U.S. NUCLEAR REGULATORY COMMISSION
REGION I

Report No. 50-289/84-22

Facility Name: Three Mile Island Nuclear Station, Unit 1

Inspection Conducted: July 23 - 27, 1984

Attachment 1 May 22, 1984 HPI TEST RESULTS

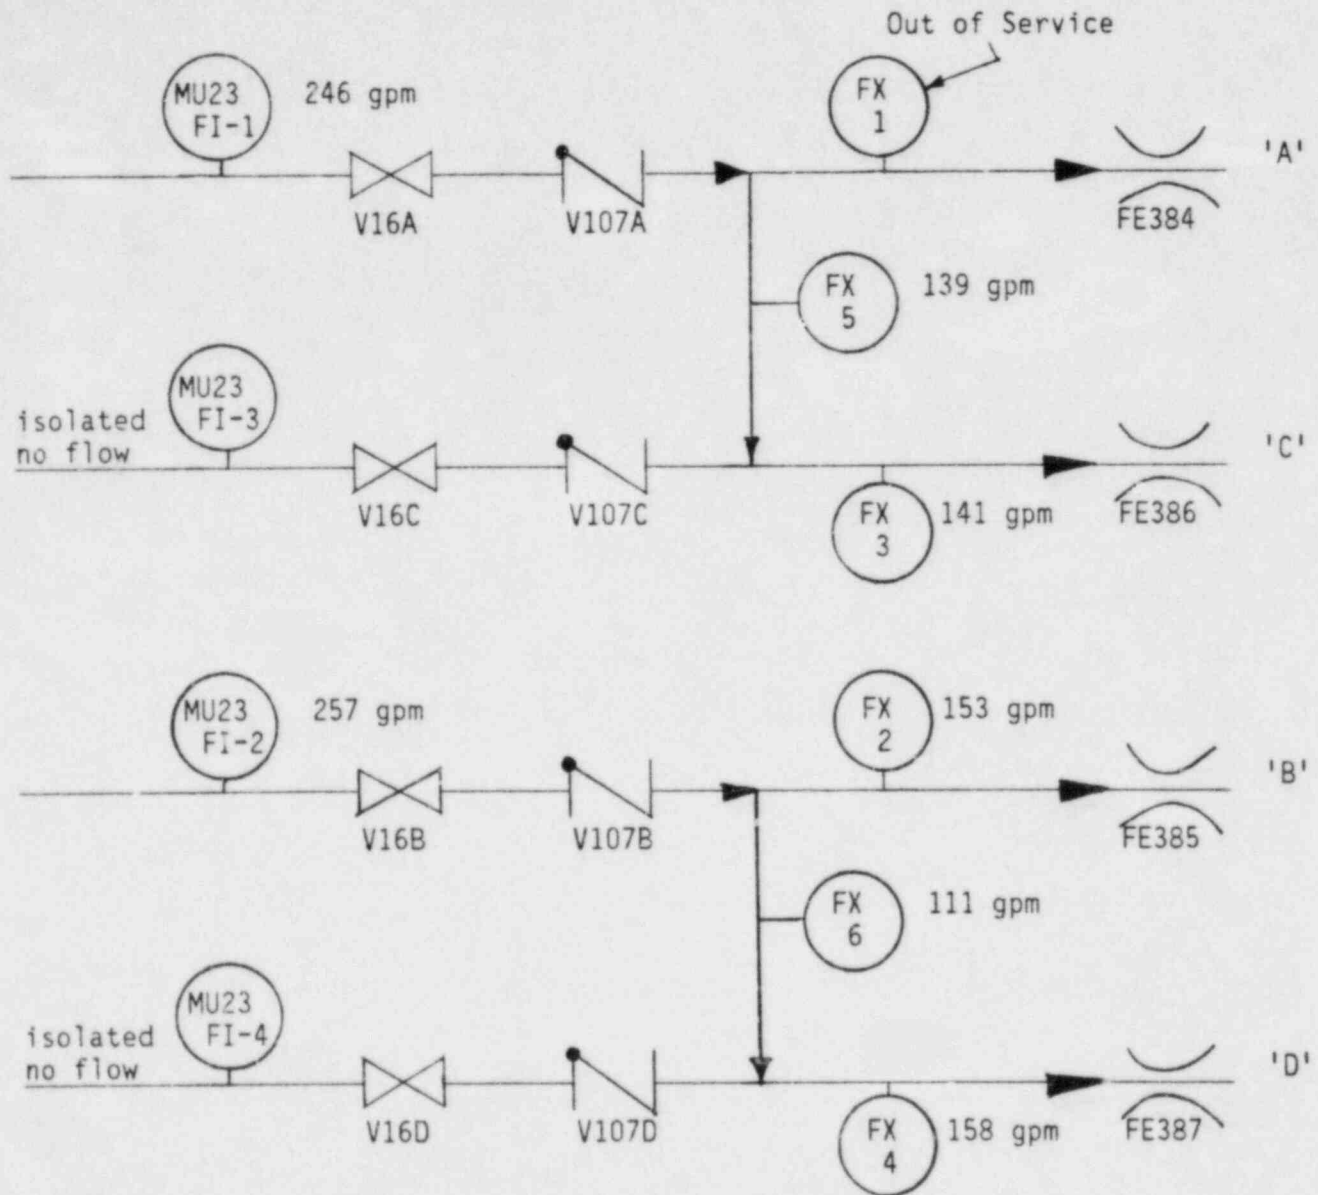
Case 1: RCS Pressure = 1200 psig, MU-P-1A Running. The measured flow is depicted in the Attachment 1.

The total measured injection flow through the three lowest flow legs exceeded the required flow of 306 gpm. However, the flow readings from the temporary Controlatron external flow measuring instruments were not consistent, as evidenced from the large deviation between FX6 and FX4. Furthermore, reading from MU23 FI2 did not agree with FX2 and FX4. These readings failed to demonstrate the fluid continuity. The licensee's Technical Functions group are currently assessing these problems.

Attachment 2 May 26, 1984 HPI TEST RESULTS

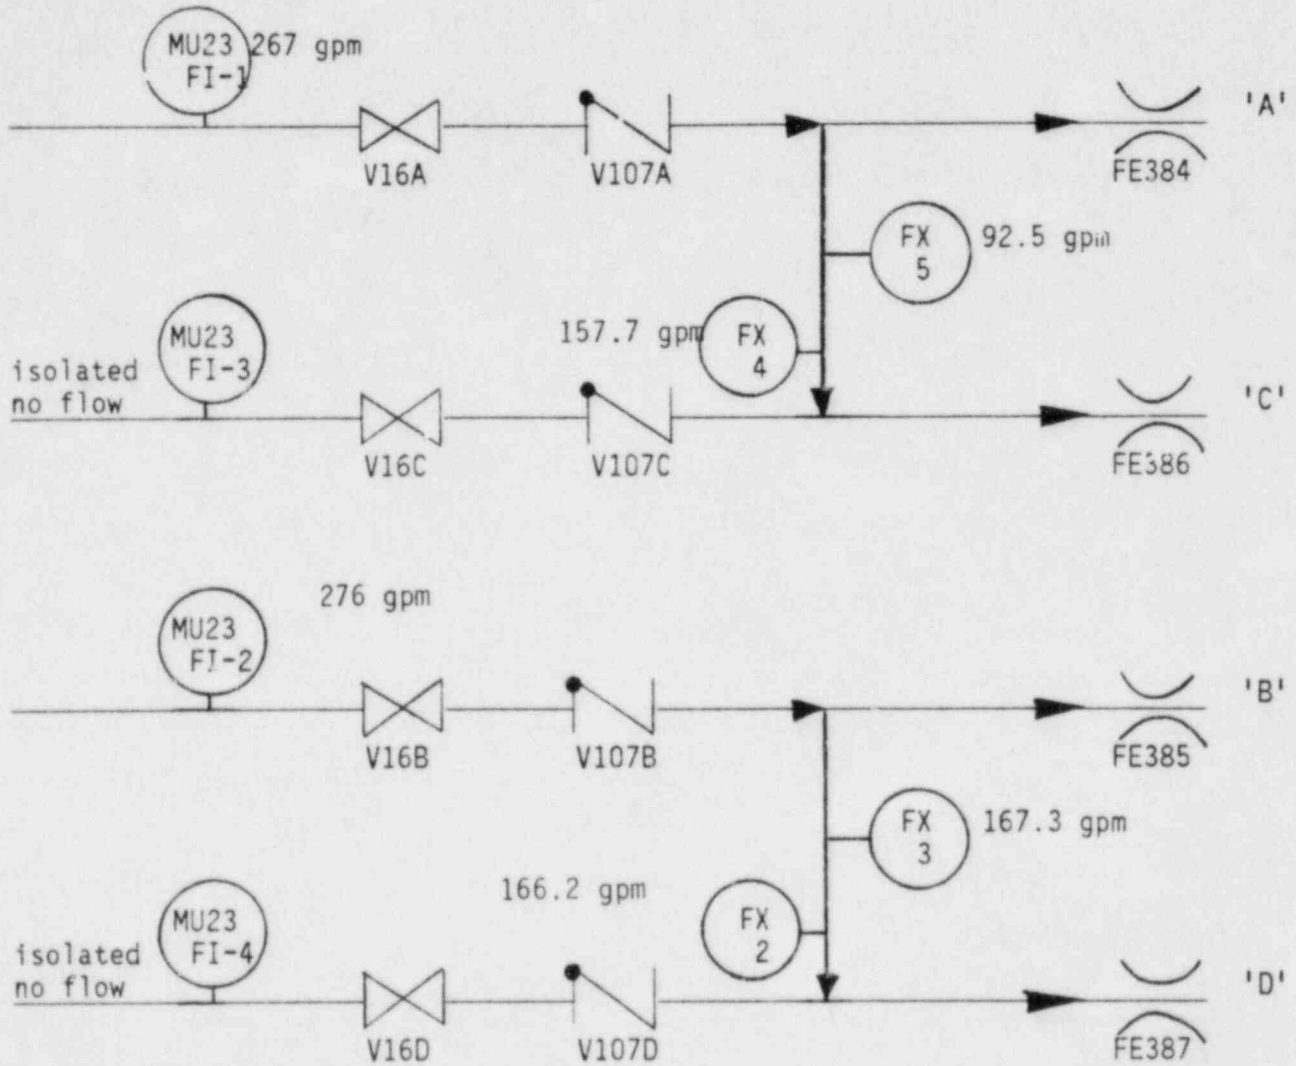
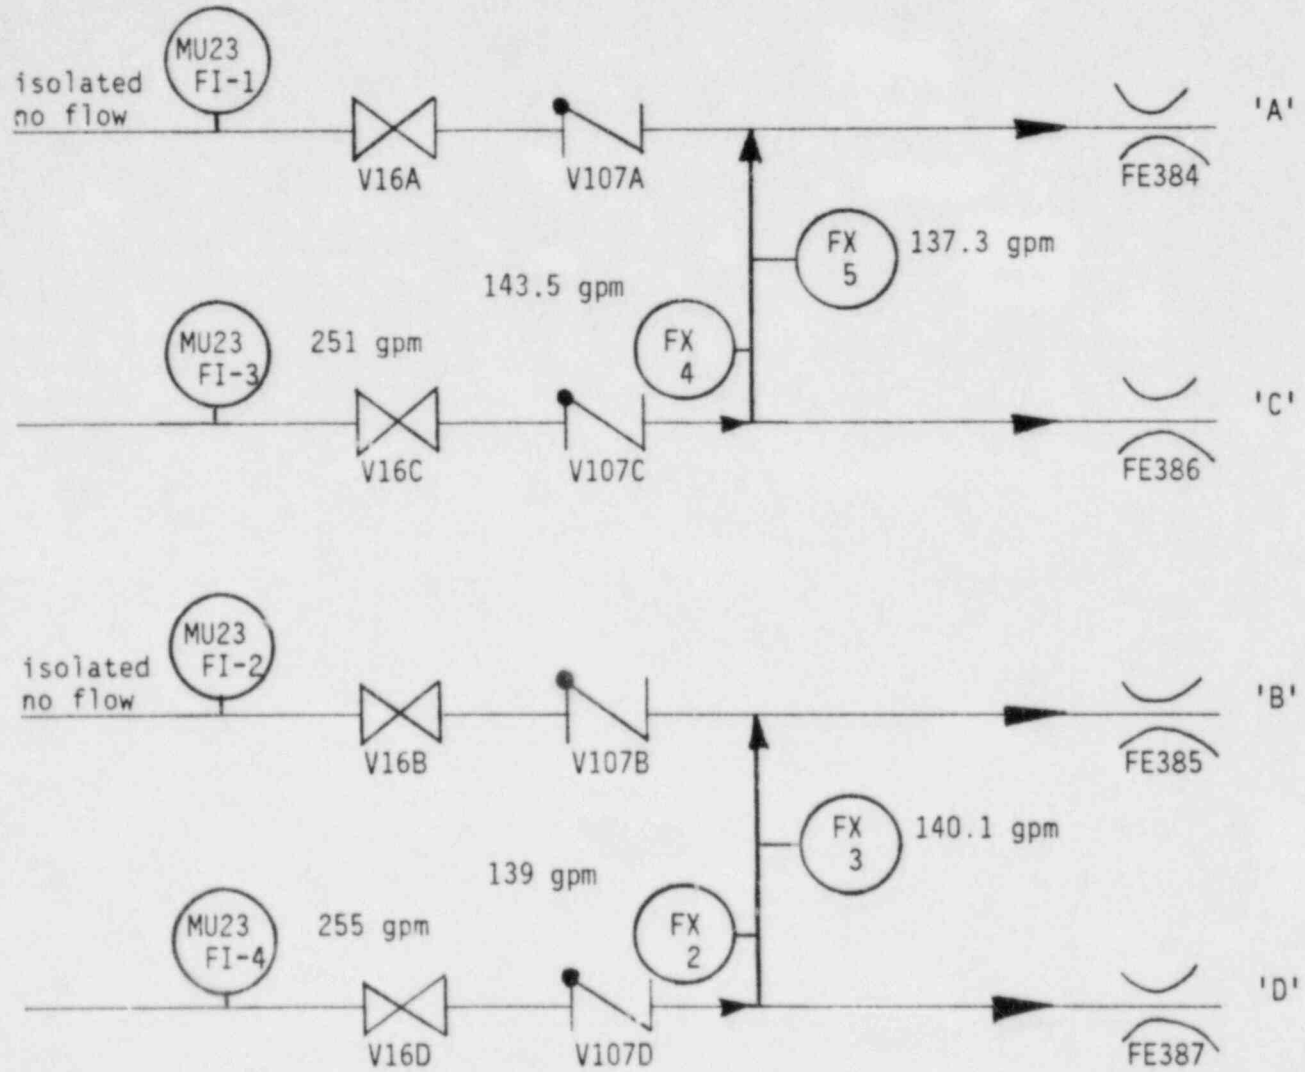
The large variation in the response of the Controlatron flow instruments was attributed to the improper locations of these instruments. The presence of sonic wave obstacles such as cavitating venturis and pipe bends in the instrument nearby, caused the Controlatron reading to be less reliable. The test was repeated on May 26, 1984 with modifications on the Controlatron location. Two Controlatrons were located on each cross leg and the remaining injection line Controlatrons were removed. The test was performed twice at RCS pressure of 800 psig with MU-P1A and MU-P1B running, respectively. The test results are summarized in the Attachment 2.

Only the MU-P1B running case showed consistent readings of Controlatrons. The split flow derived from this set of test data met test acceptance criteria.
